Special Systems Meeting Monday August 26, 2024
EEC responses in Red

Response to SPECIAL SYSTEMS SUBMITTALS
08/06/2024

The library staff has found many problems and irregularities with the submittals. They are organized below in the following order:

Accounting of Sound Rack Cabinet
(per Project Manual section16600)

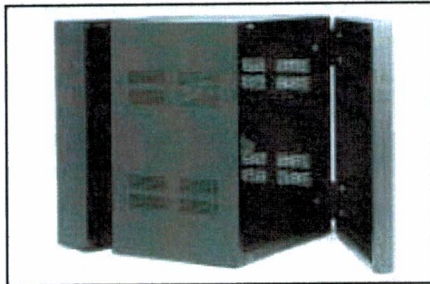
1) The Atlas 340-21B sound rack is too small to fit the specified devices .(The rack specified holds 12U, items specified use 15U). **This needs to be replaced with Atlas 340-28B** which holds 16U. EEC WILL PROVIDE THE LARGER RACK AT NO EXTRA COST

MEETING ROOM
109

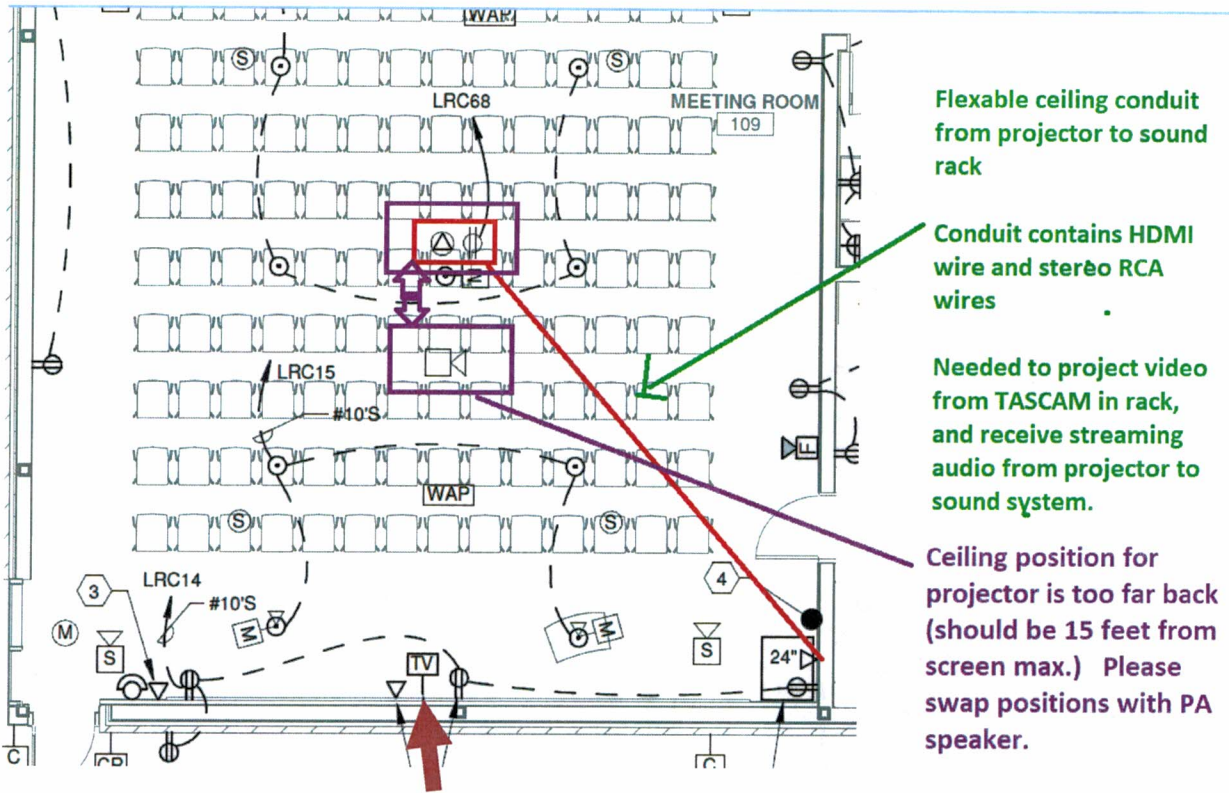
2) There is a power outlet and an ethernet jack in the ceiling for a projector. The plans need to indicate a flexible conduit tube between this projector and the metal sound rack. Inside this conduit will be two (2) HDMI video cables and a stereo RCA audio cable. Estimated cable length is 50 feet. See attached diagram showing placement. WILL PROVIDE ETHERNET JACK POWER BY OTHERS

Flexable ceiling conduit from projector to sound rack

Conduit contains HDMI wire and stereo RCA wires

Needed to project video from TASCAM in rack, and receive streaming audio from projector to sound system.

Ceiling position for projector is too far back (should be 15 feet from screen max.) Please swap positions with PA speaker.

Mount the Ethernet, TV and power outlets at the same standard floor height (18"), due to having a projector screen instead of a flat-screen TV at this location.

1 PROJECTION SCREEN FRAMING DETAIL
ASK016   1/2" = 1'-0"

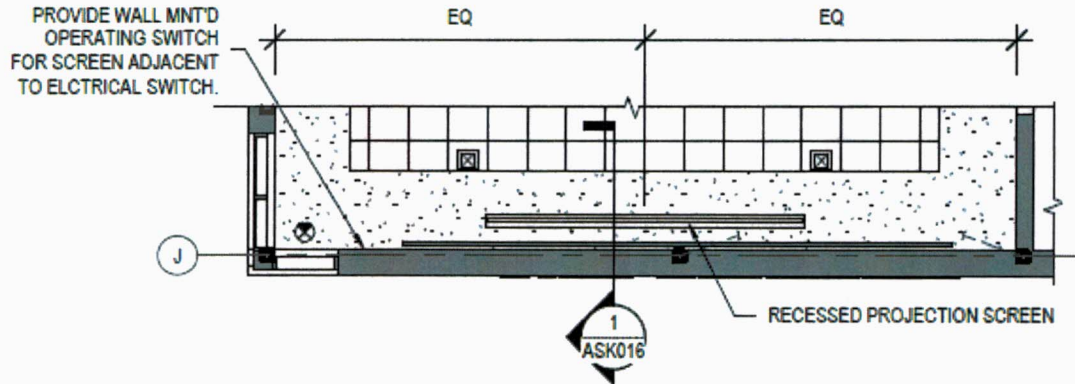
5) Architect drawing ASK016 and project manual section 11130-1 specifies a motorized projection screen in the main meeting room for the video projector, which was not in the submittal. **Please add the motorized screen.** Preferred screen size is 88" x 140".

WILL PROVIDE MOTORIZED SCREEN

Possible motion detection for library entrance

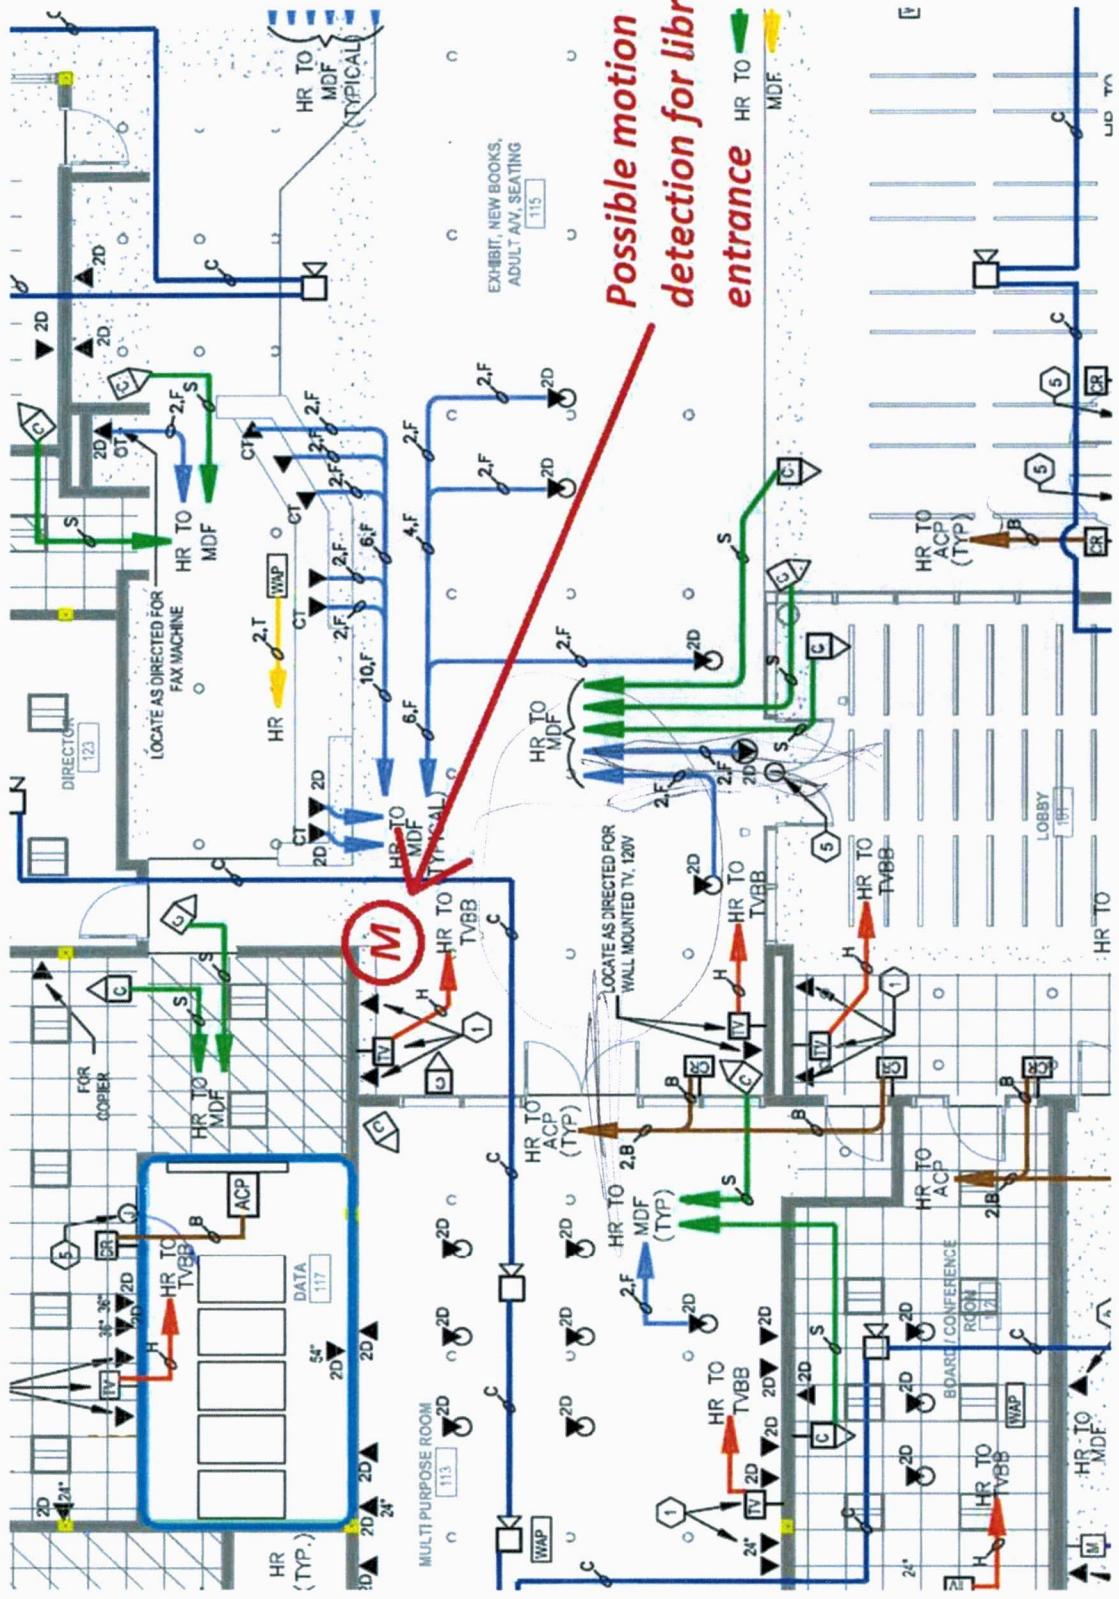
5)   Motion detectors are shown next to all external doors, which is fine.   However, if the
lobby is used after hours, the library needs a way to protect for a possible break-in
entrance from either the inside entrance doors from the lobby or the multi-purpose
room. DO YOU WANT ME TO PRICE THIS UP?

I have attached a drawing showing a suggested location for a motion detector to
compensate for this and should monitor both doors.

SPECIFIC NOTE

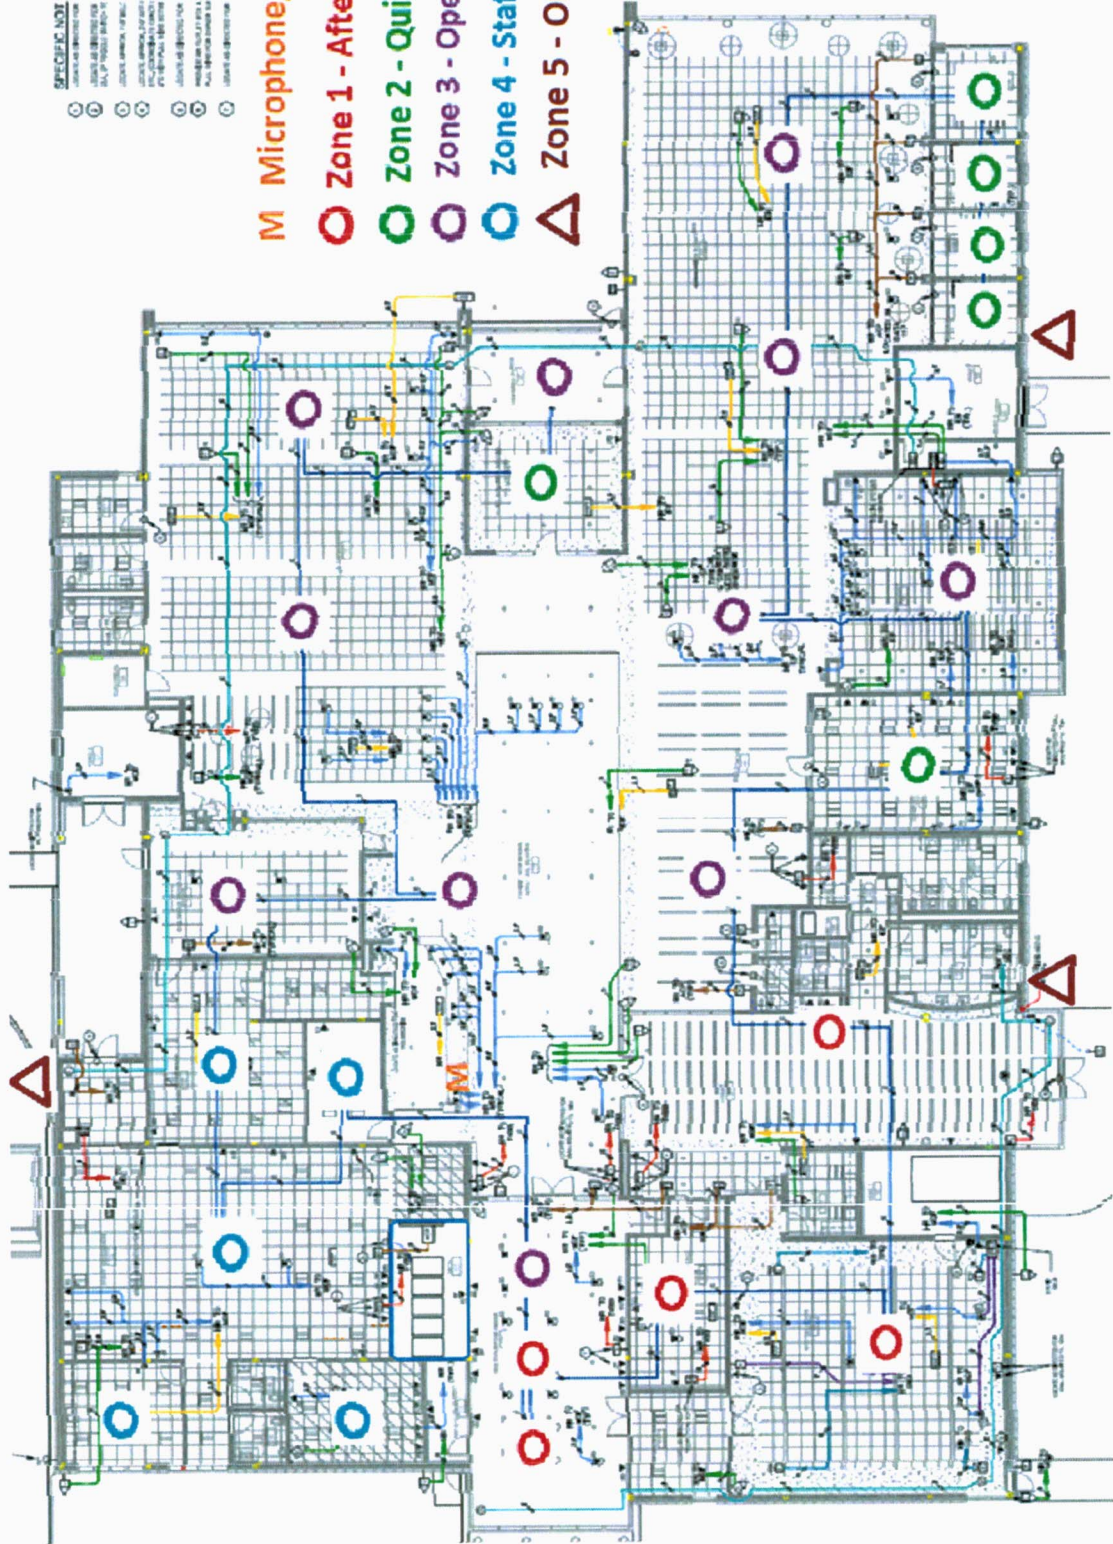
1. The 70v speaker wiring is one zone with one big "daisy chain" connecting all of them. This one-zone solution is not recommended. Separate zones are need for the "library open area", "after-hours meeting rooms", "staff area", and "quiet study areas". **Please split the one-zone system into five zones**.   See attached diagram.
DO YOU WANT ME TO PRICE THIS UP TO SEPERATE THE ZONES?

4. Outside paging was overlooked.   Please add 3 weatherproof horn speakers to the plan. DO YOU WANT ME TO PRICE THIS UP?

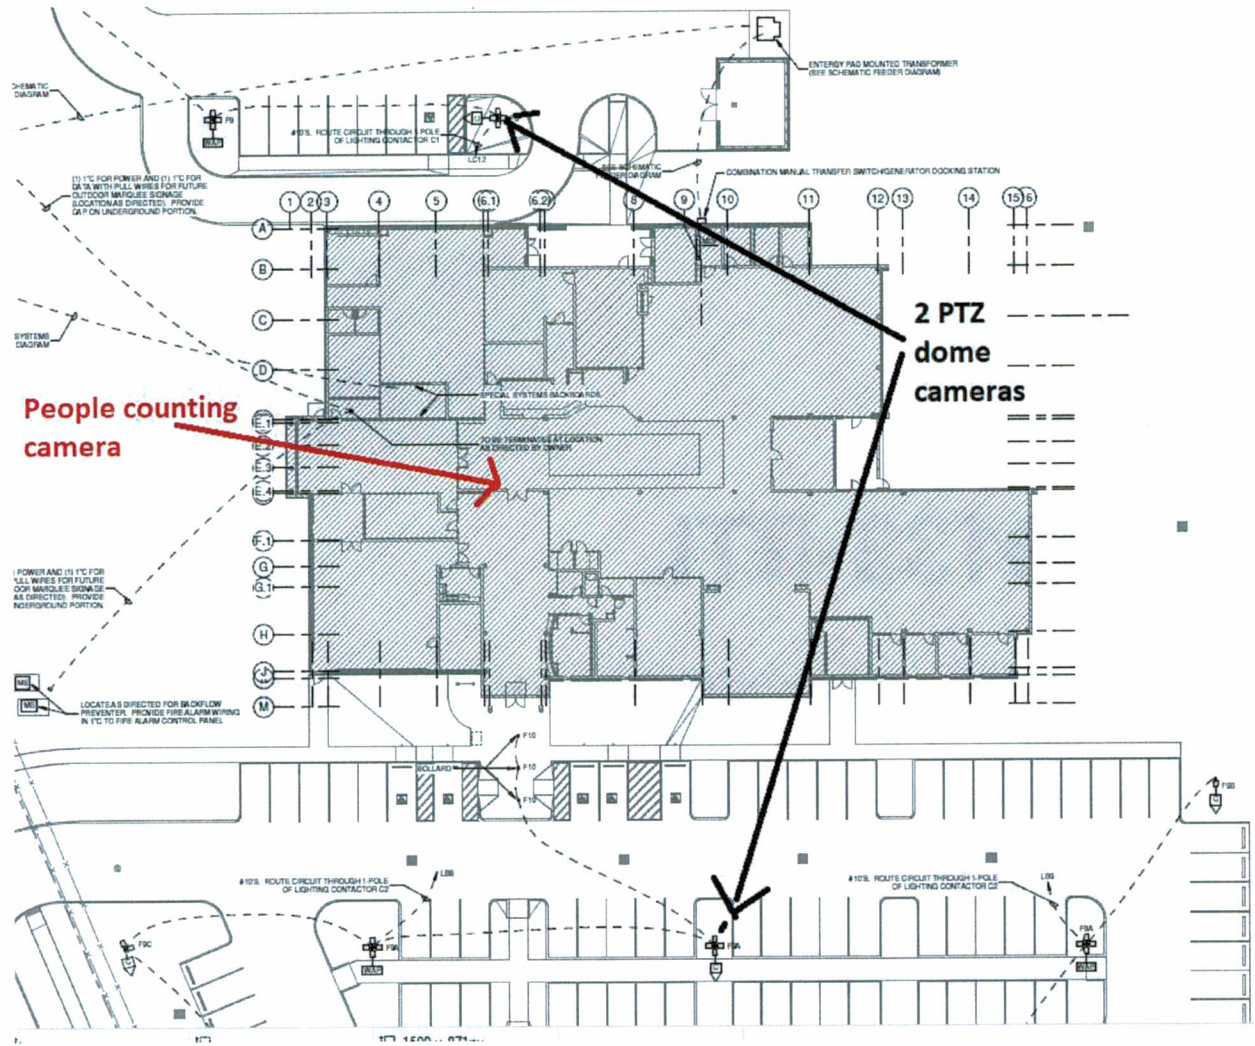
1) Please replace two of the outdoor cameras with **VIVOTEK SD-9384-ELH** or equivalent outdoor PTZ dome cameras. DO YOU WANT ME TO PRICE THIS UP?

- One of them should be mounted on the lighting pole in the back staff parking lot, since it is the only security camera for this lot and it will allow us to change directions to focus on the chiller/dumpster area and also the staff entrance if problems occur.

- The second PTZ camera should be located on the lighting pole in the center of the front parking lot and will allow us to view any "dead spots" not picked up by the other cameras.

See attached diagram.

2) Please add a **VIVOTEK SC9133-RTL** people counting camera mounted in the ceiling just inside the library entrance from the foyer, if compatible with the NVR. The plans already have an Ethernet jack mounted in the ceiling in the architect's drawings for this purpose, but it was not marked as a camera. Our current Geovision security camera system has a camera already doing this job, and we do not wish to run 2 camera security systems at the new library. DO YOU WANT ME TO PRICE THIS UP?

People counting camera

2 PTZ dome cameras
